STORM SEWER IMPROVEMENTS

LOT 1, BLOCK 1 J.I. CASE ADDITION

3301 S. Hoover
CITY OF WICHITA, KANSAS

AS BUILTS
 Contractor: Ewertz Excavation
 Project Inspector: Larry Gann
 8/11/2022
KEMILLER ENGINEERING PA
 117 E. Lewis, Wichita, KS 67202 (316)264-0242

**SWS Lines
1A/1B & 2**

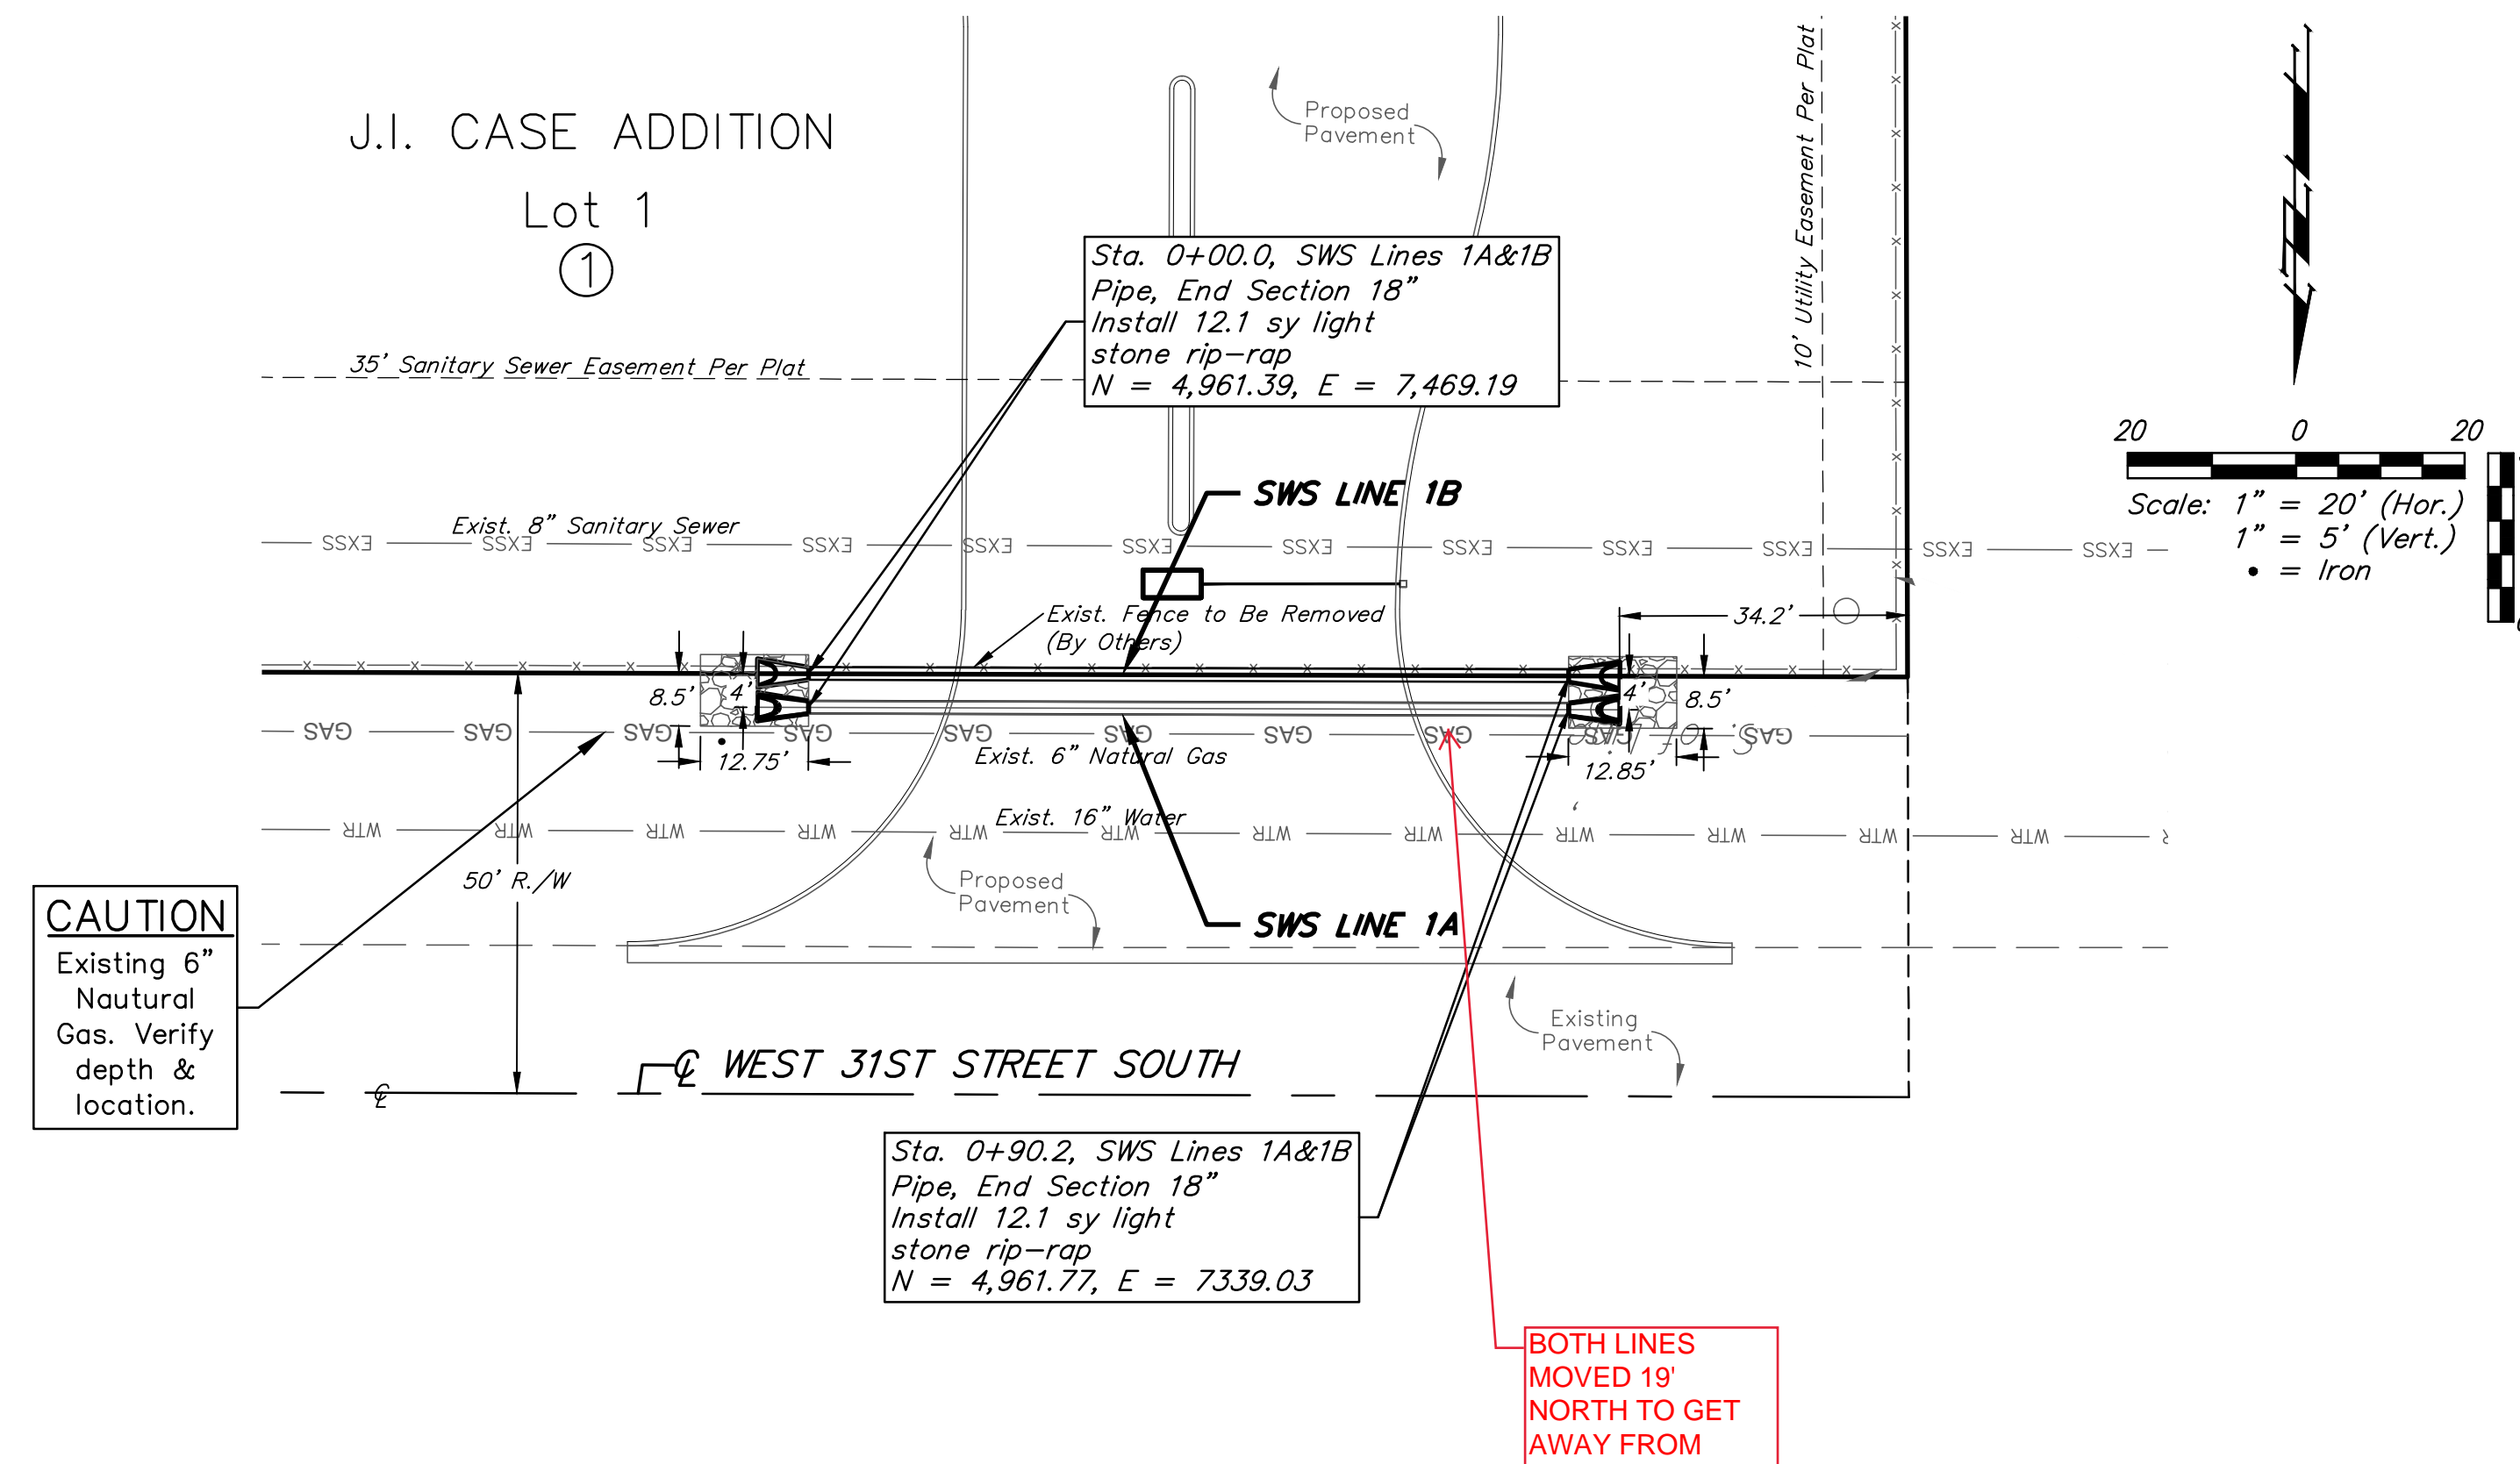
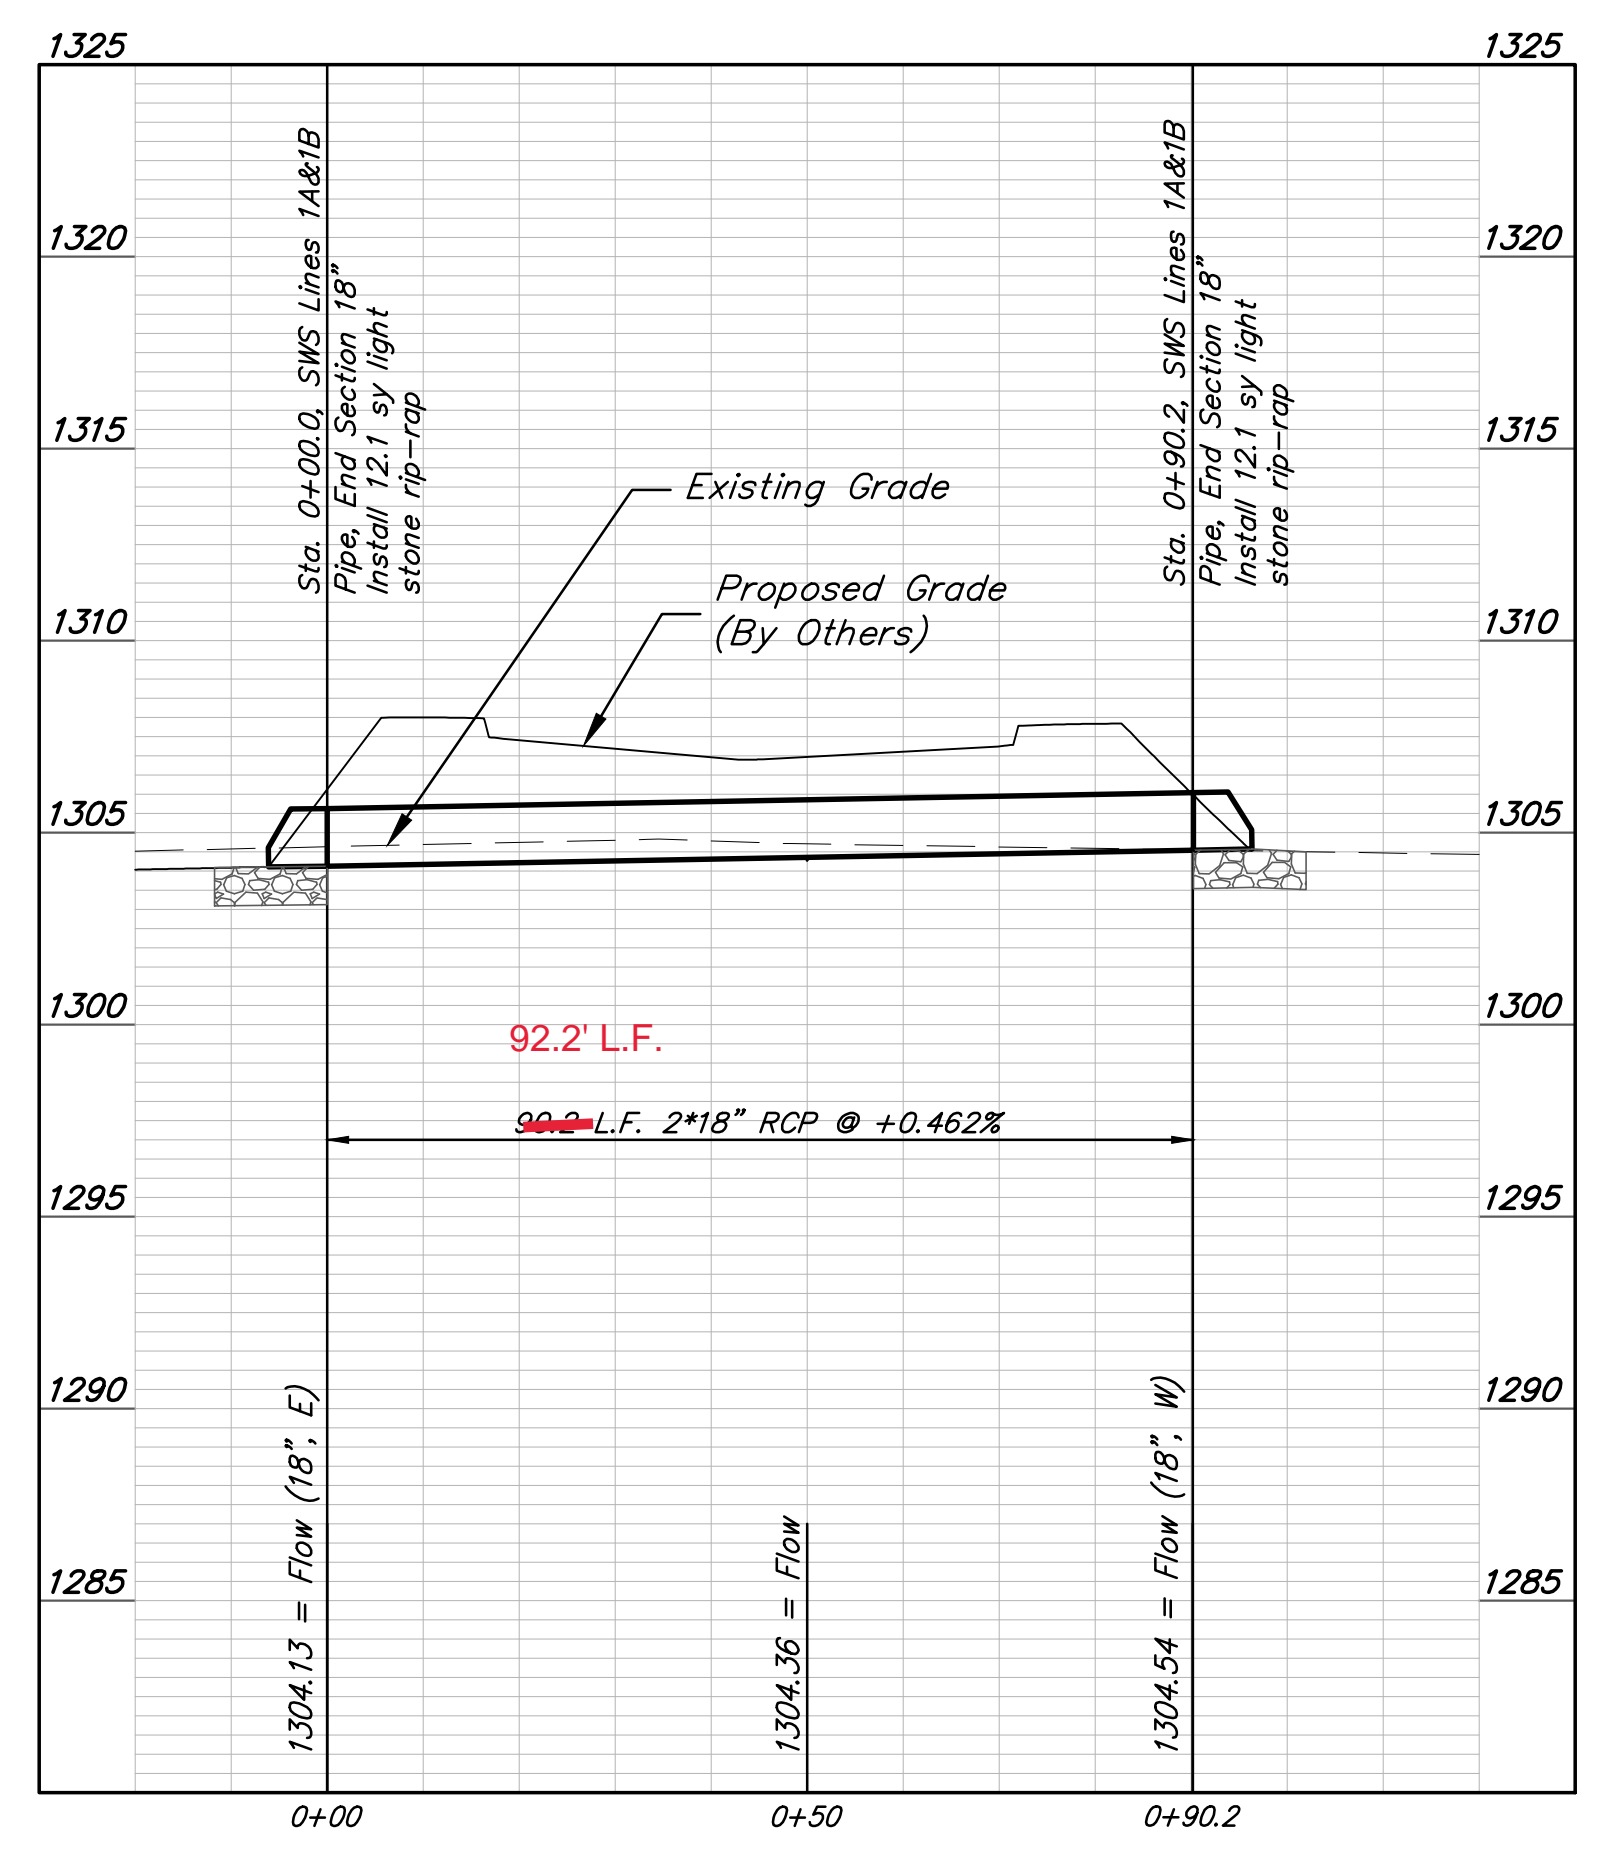
**BOTH LINES
MOVED 19'
NORTH TO GET
AWAY FROM
FENCE AND
ADDED 2' TO THE
LENGTH OF
BOTH LINES**
